DESIGN 	DRAWN BY 	DART AEROSPACE LTD HAWKESBURY, ONTARIO, CANADA	
CHECKED 	APPROVED 	DRAWING NO. DSI 9241	REV. A SHEET 1 OF 1
DATE 02.10.29		TITLE NEW SPACER	SCALE NTS
A	02.10.29	NEW ISSUE

## **DART SERVICE INSTRUCTION**

TO AMEND ICA-D105-674 REV. Ø  
REF. FAA STC: SR00910SE

ON D105-674-011 CHANGE 002 OR LATER SKIDTUBES, D3176-1 BUSHING AND D3176-3 NUT HAVE BEEN INSTALLED AS SHOWN IN FIGURE 1 BELOW:

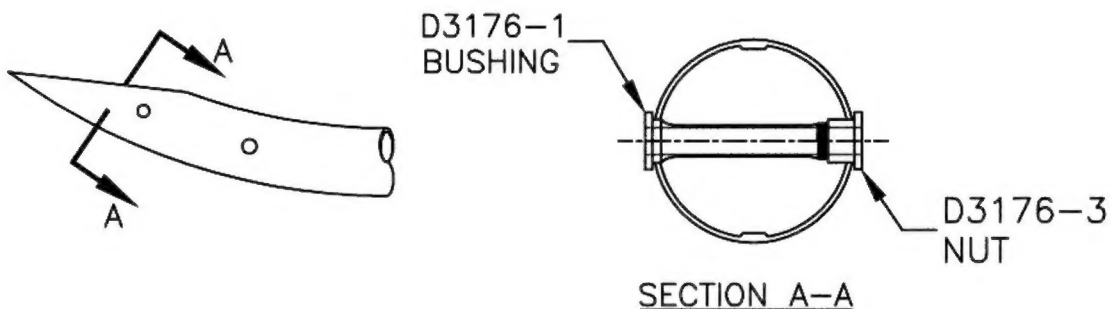
TO CONVERT D105-674-011 CHANGE 001 TO D105-674-011 CHANGE 002,

- 1) DRILL OUT EXISTING D2971 SPACER (Ø0.625)
- 2) OPEN TO Ø0.750 (2 PLACES)
- 3) TOUCH-UP ALODINE PER MIL-C-5541
- 4) INSTALL D3176-1/-3 PER SECTION A-A.
